FINAL MITIGATION PLAN

Greenbrier Stream Restoration Site
Yadkin County, North Carolina

Re: NCIRT Review and USACE Approval of the NCDMS Greenbrier Stream Restoration Site /
Yadkin Co./ SAW-2018-01755/ NCDMS Project # 100086

**Subject: Mitigation Plan Report and Construction Plans
Greenbrier Stream Restoration Project
Yadkin River Basin Cataloging Unit 03040101
DMS Project ID #100086
Contract # 7616**

FIGURE 2

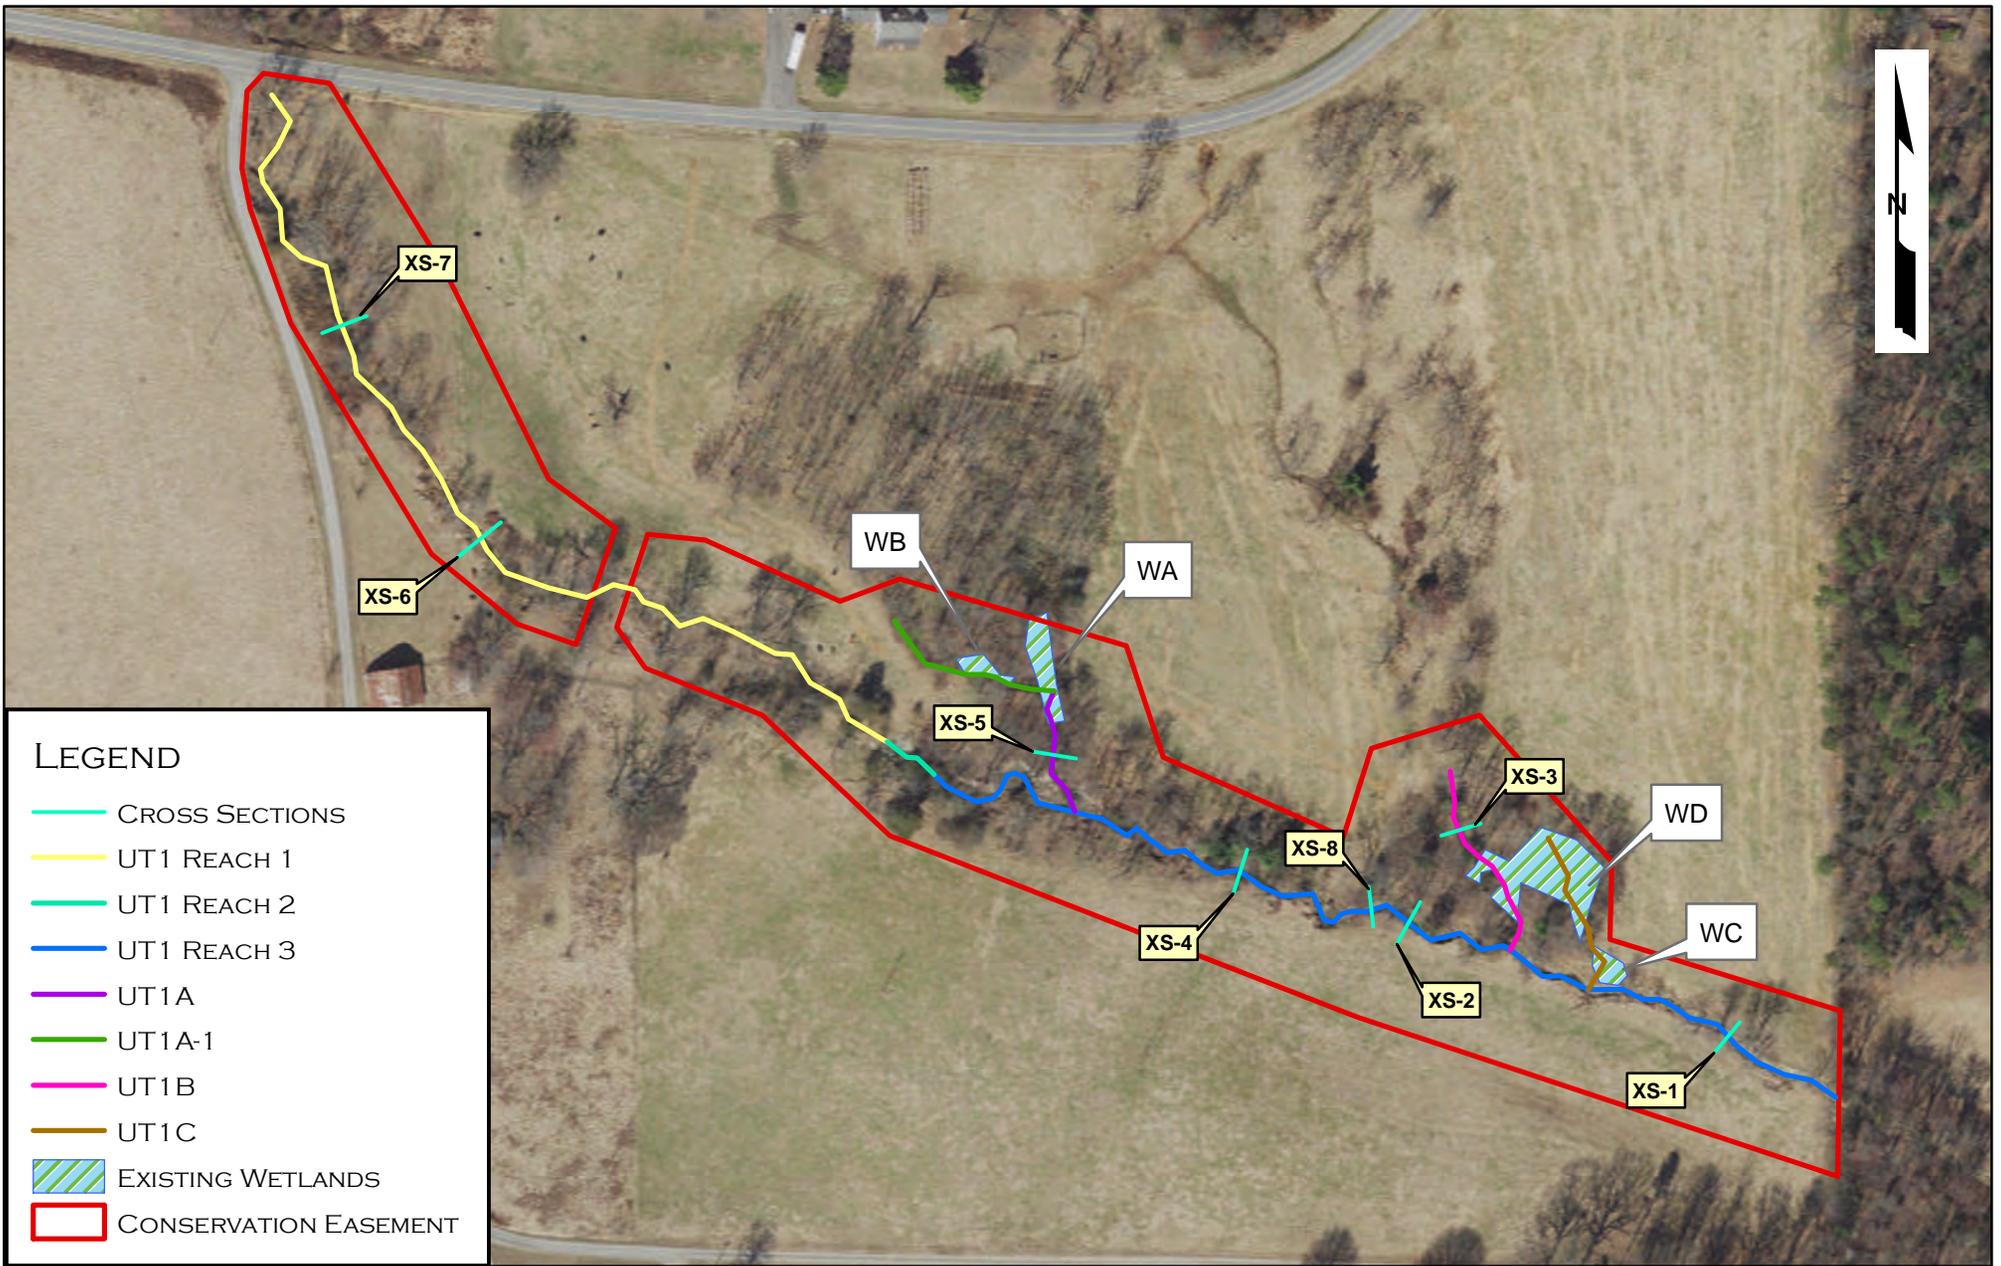
14. *Appendix 4 – a. The cross-section sheets River Name is identified as UT to Meadow Brook. If this is the project site, please rename for clarity to either Greenbrier Stream Restoration Project or UT to South Deep Creek (as noted on page 1); b) Please provide a labelled map correlating to plotted cross sections 1 through 8; and c) For Table 2, please separate out stream and vegetation survey monitoring dates.*

- Response: The cross-section sheets have been relabeled as Greenbrier Stream Restoration Project. Figure 2 has been revised to show the existing condition cross section locations and has been labeled. Table 2 shows the dates for the

FIGURE 9

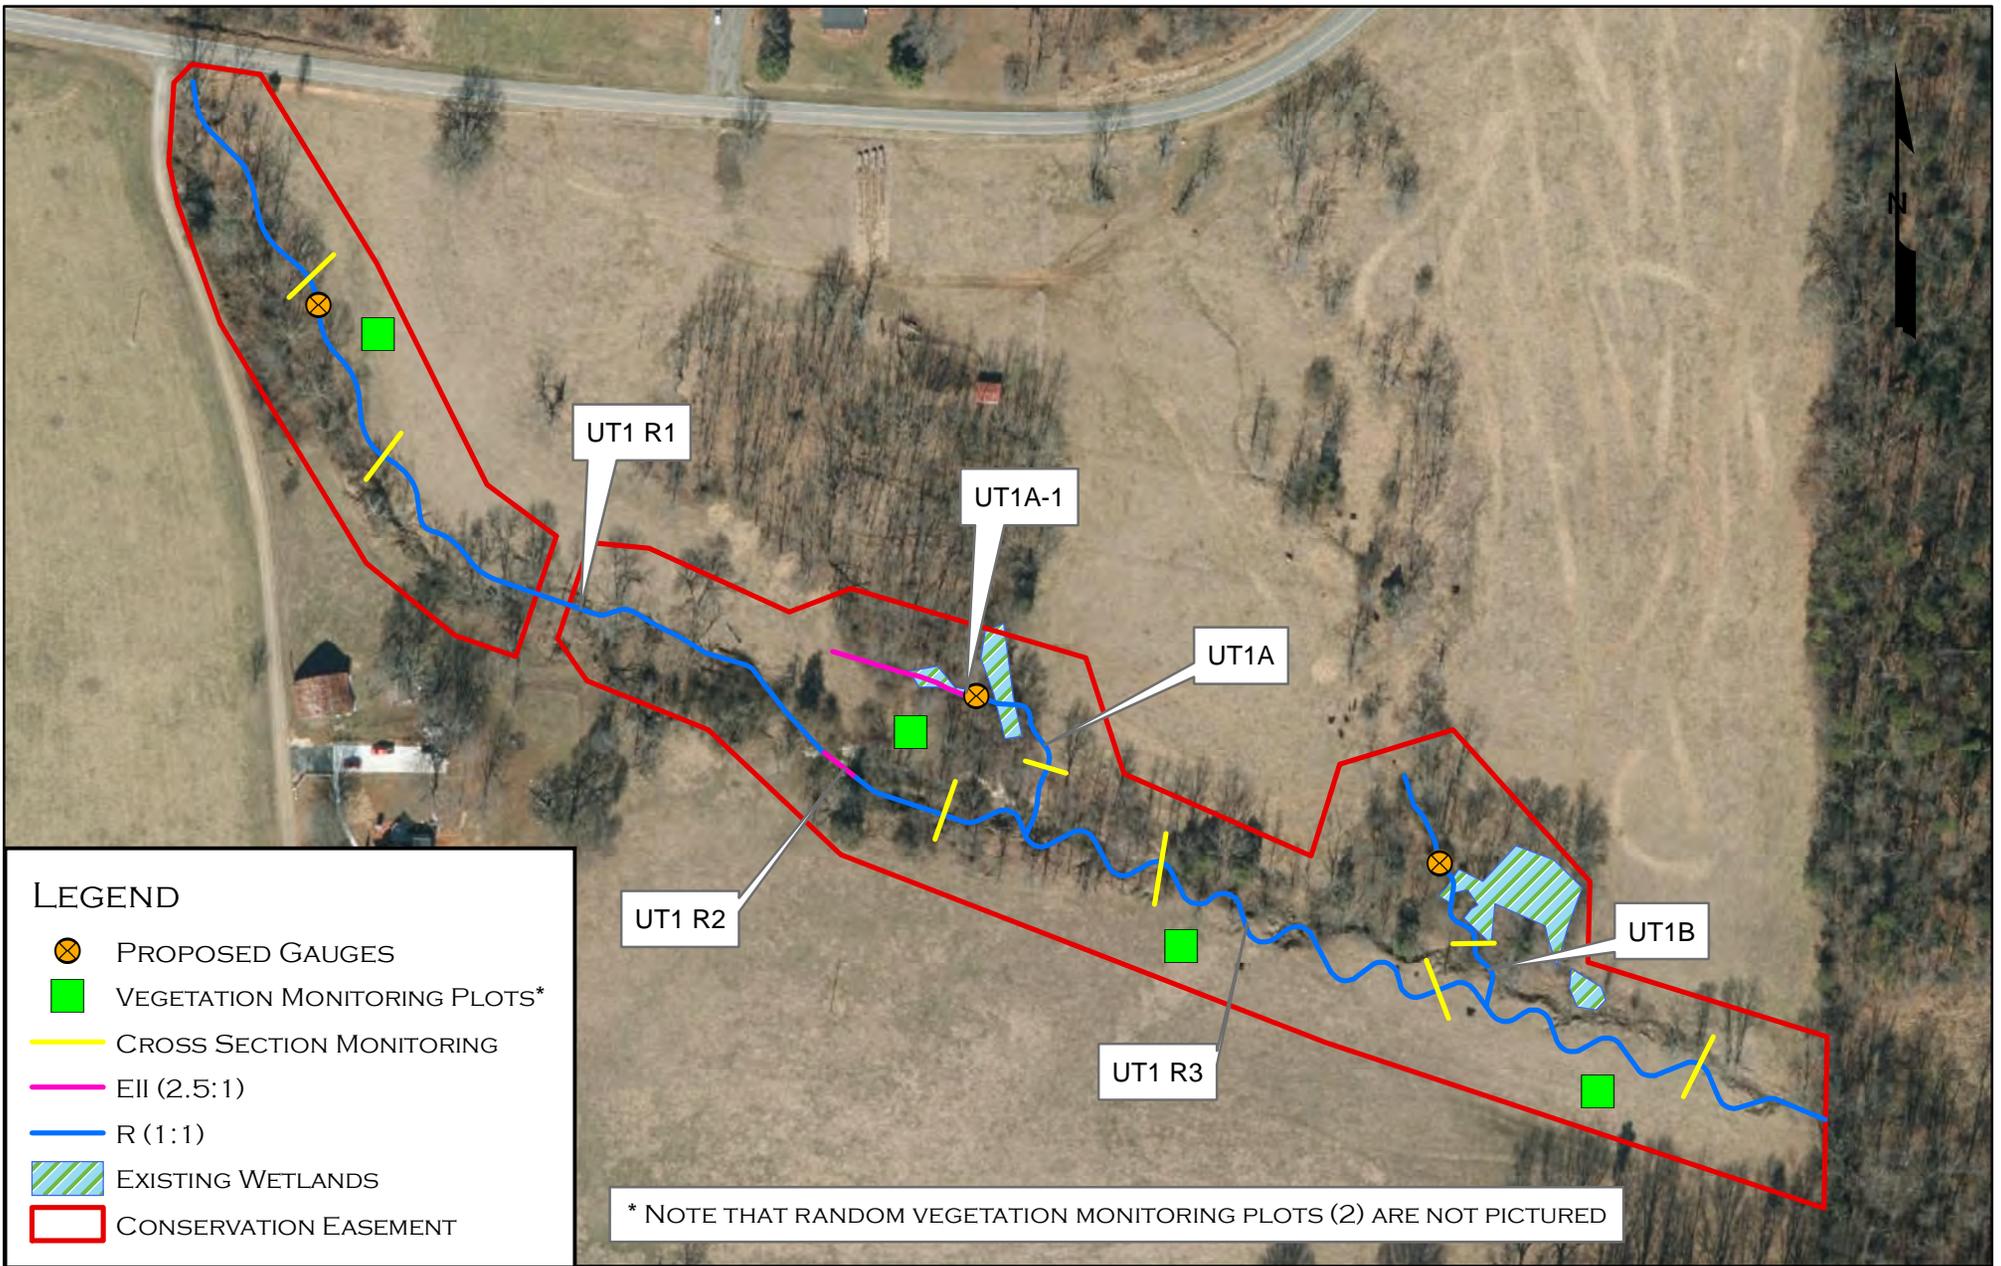
13. *Figures – On Figure 9 please indicate by line color restoration and enhancement reaches and label cross sections.*
 - Response: The stream reaches have been color coded to correspond to the approach (Restoration vs Enhancement II). An additional vegetation monitoring plot has also been added to this figure as described in comment 11 above. The cross sections will be labeled once the monitoring cross sections have been installed post construction. A CCPV map included in the Baseline and subsequent monitoring reports will show these labeled cross sections.

7. *It would be preferable to move the flow gauge on UT1a-1 to the upper third of the reach.*
 - Response: The flow gauge along this reach will be installed closer to the top of this reach. Figure 9 has been revised to reflect this.

| Table 6. | Functional Category Summary for Project Reaches |

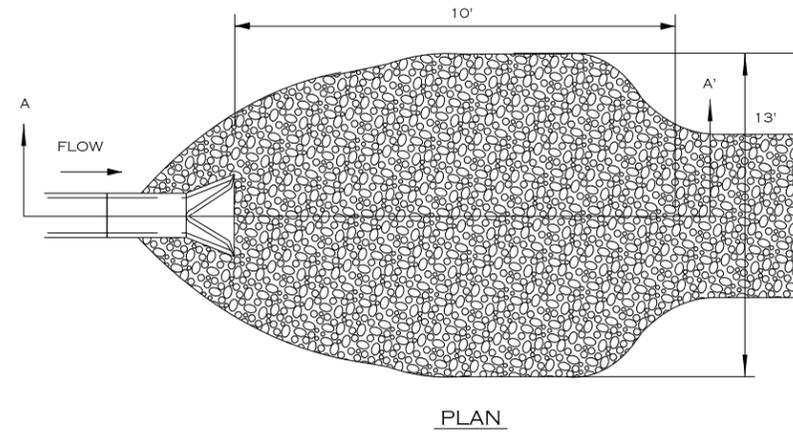
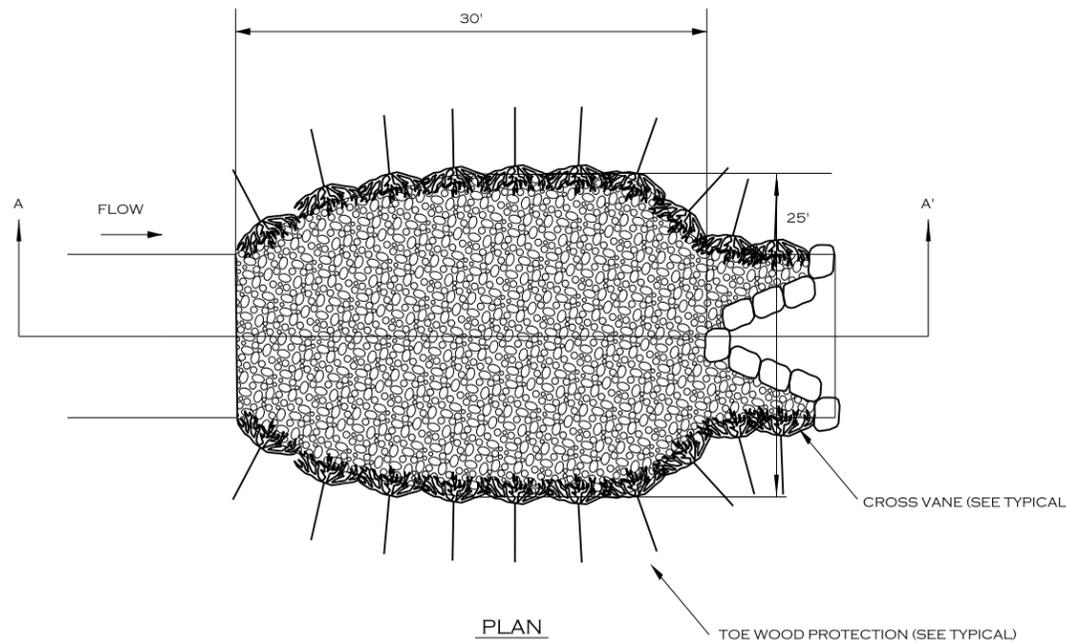
15. *Appendix 8 - Please include a plunge pool detail (as previously requested by DMS). Based on the design provided, it appears the Class 1 stone plunge pools will be functioning primarily as armored outlet structures. DWR does not support these riprap areas as stream restoration credit length.*

- Response: Stabilized plunge pools have been included in the design to ensure that high energy flows exiting the NCDOT culvert and the steep grade transition from UT1 R2 to UT1 R3 will not cause erosion. The bed elevation in the location of the upstream plunge pool will be raised approximately 8' to reconnect the downstream section of this stream to the section above this culvert. The plunge pools will be deep and provide an area for energy dissipation. Lining the pool with stone will prevent degradation. The pools will hold water year-round providing much needed pool habitat in a system that currently lacks pools. It is expected that detritus and fines will deposit in the pools which will make these sections function more naturally over time. Additionally, the downstream plunge pool will have toe wood installed along the banks, which will protect the stream banks and provide large woody debris. The level of required intervention to raise this channel and the functional benefits to habitat, aquatic passage, and stability should warrant restoration credit in these sections regardless of the need to harden the plunge pool with quarried stone. Two details showing both plunge pools have been added to the plans.
